## **CONSERVATION HALTON**

Re: **Ninth Line EA, Halton Region**  
**Natural Heritage Assessment - Interim Report**

**Re: Schedule 'C' Class Environmental Assessment Study – DRAFT Environmental Study Report  
Ninth Line (Regional Road 13) Transportation Corridor Improvements from Highway 407  
to 10 Side Road (Regional Road 10), Halton Hills, Regional Municipality of Halton  
Halton Region Project No. PR2876  
Response to Conservation Halton Comments on SWM Report**

**Re: Ninth Line Transportation Corridor Improvements (Region of Halton)  
Class EA – UEM Draft SWM Report, CH follow up comment post February 18,  
2016 meeting  
CH File: MPR 664 (Ninth Line Class EA)**

Title  
**NINTH LINE**  
PLAN AND PROFILE  
3+000 TO STA. 3+300  
Date: April 2016  
Consultant's Project No. 14-508  
Regional File No. PR-2876  
Drawing No. SHEET 11 OF 22

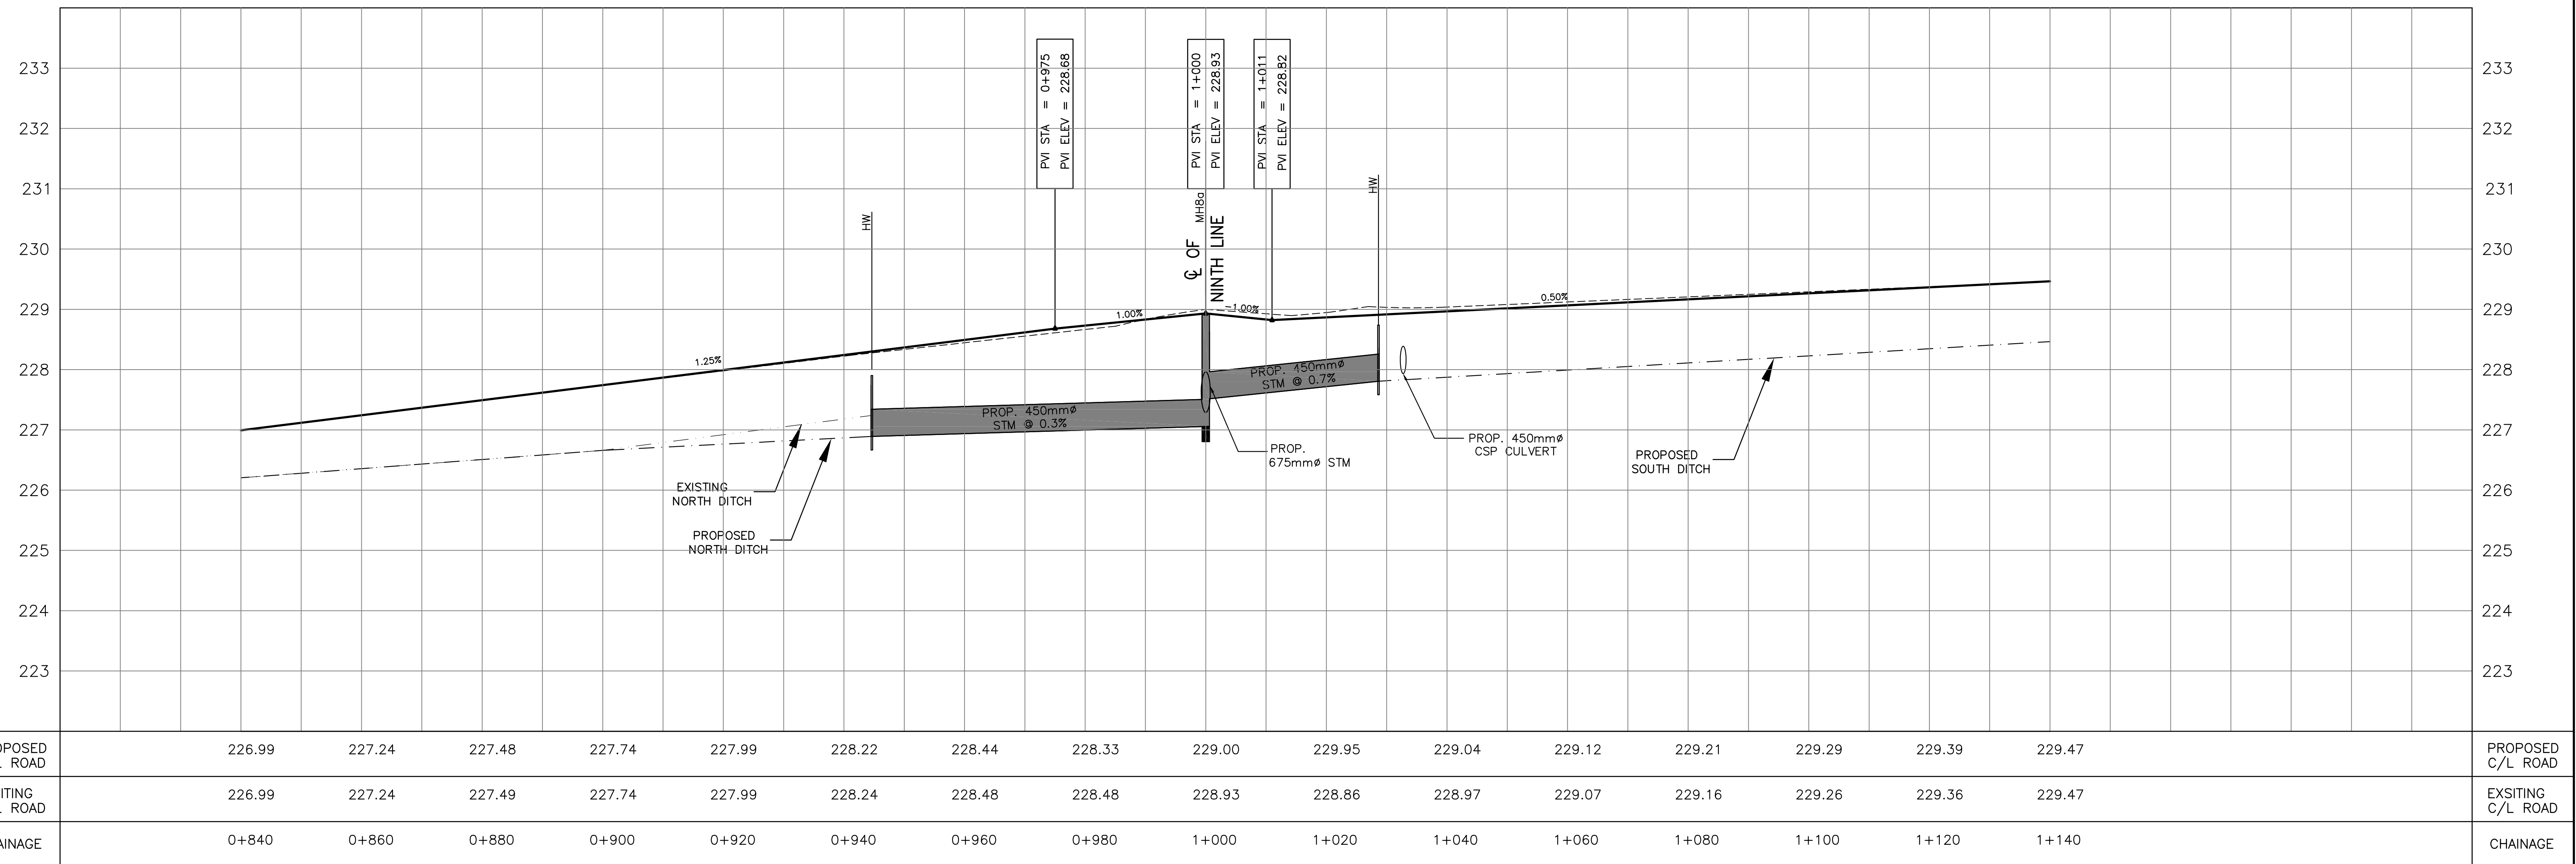
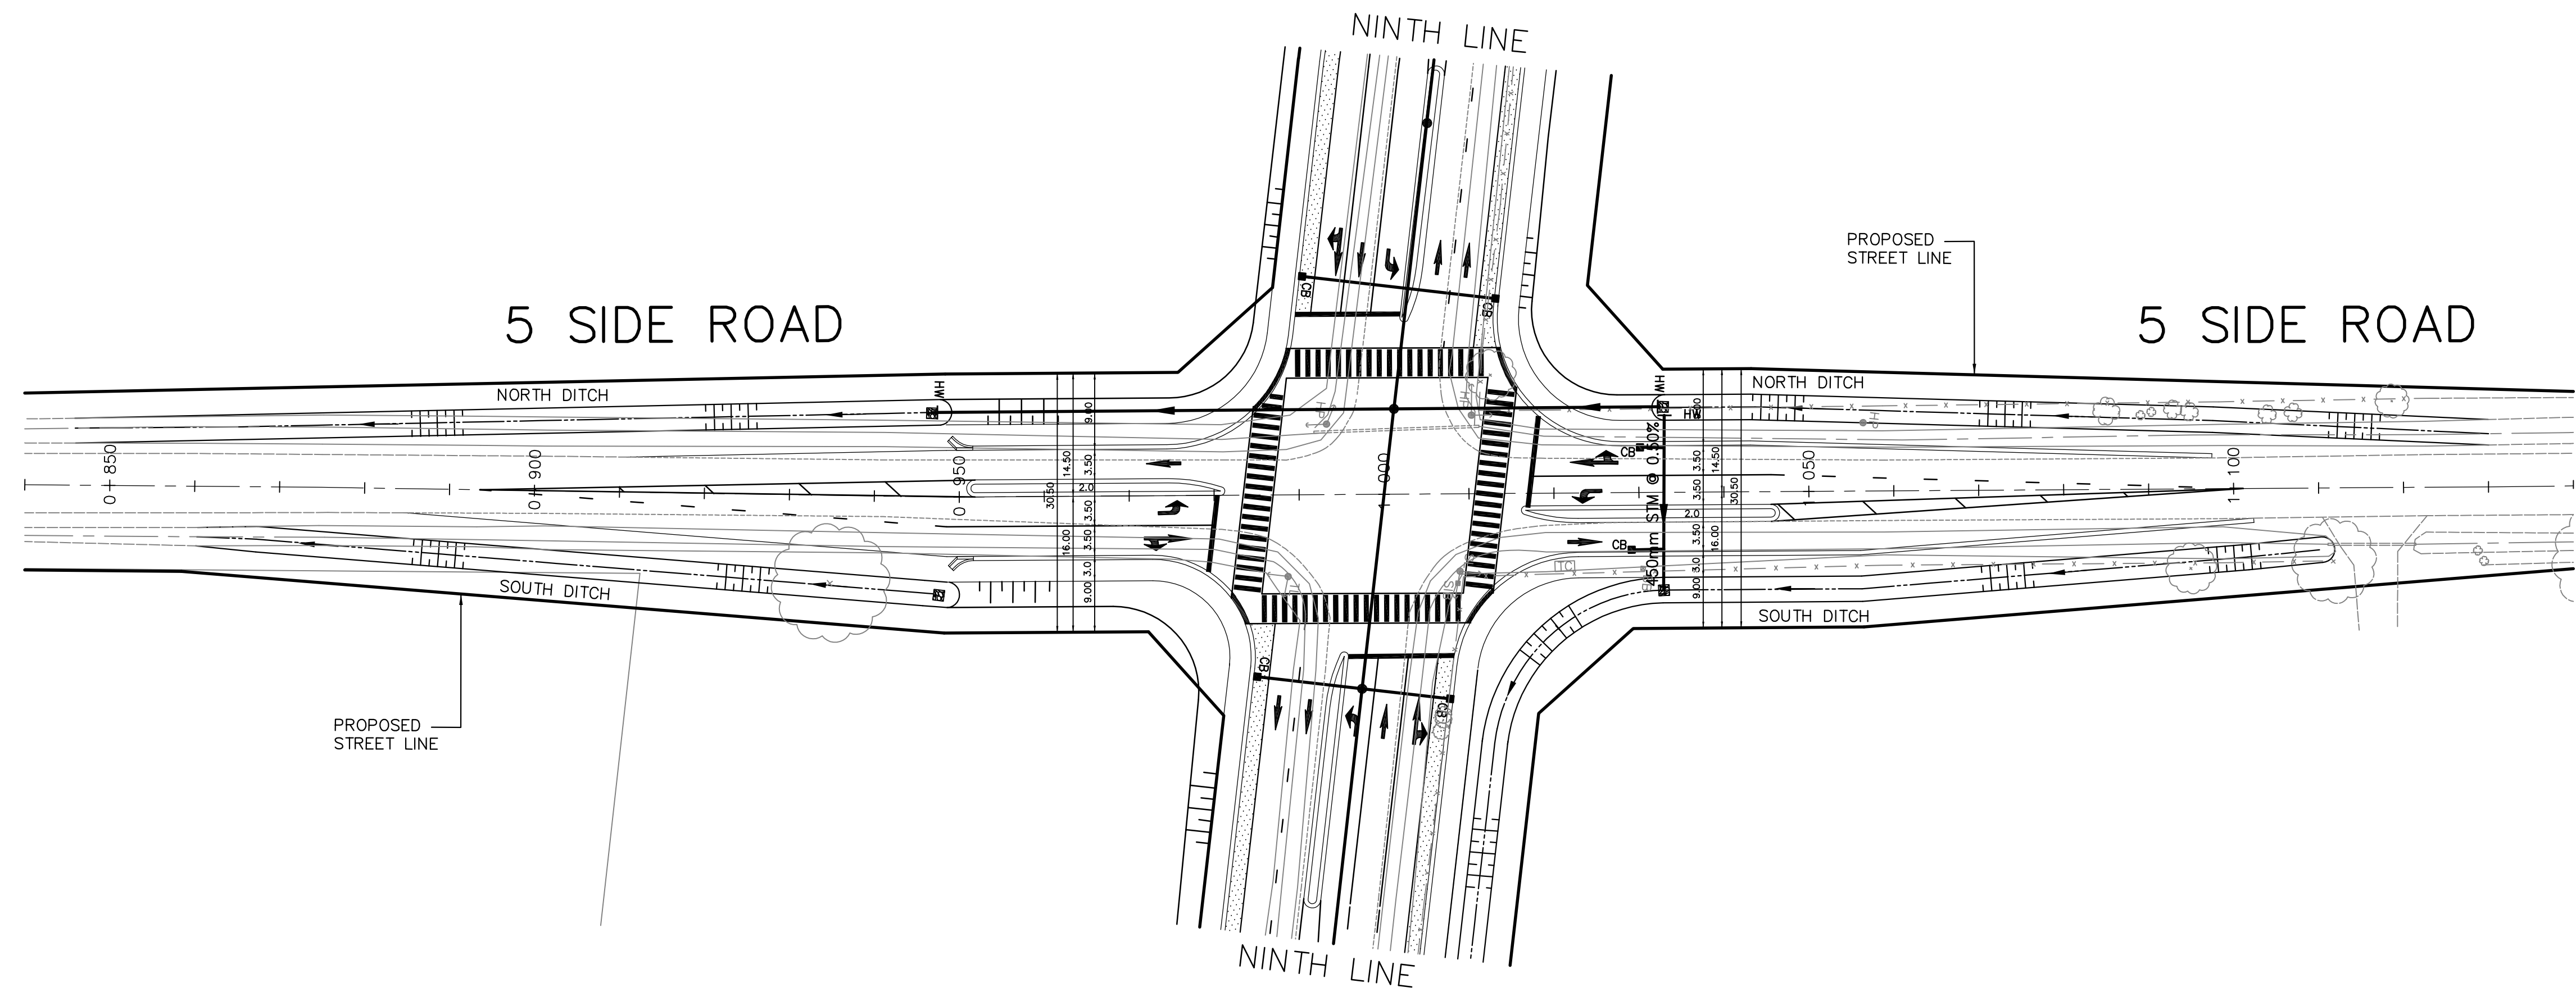
Drawing P11.pdf shows the plan and profile along Ninth Line and drawing P22.pdf shows the plan and profile along 5 Side Road (please note the label “Proposed South Ditch” should read “Proposed **North** Ditch”).
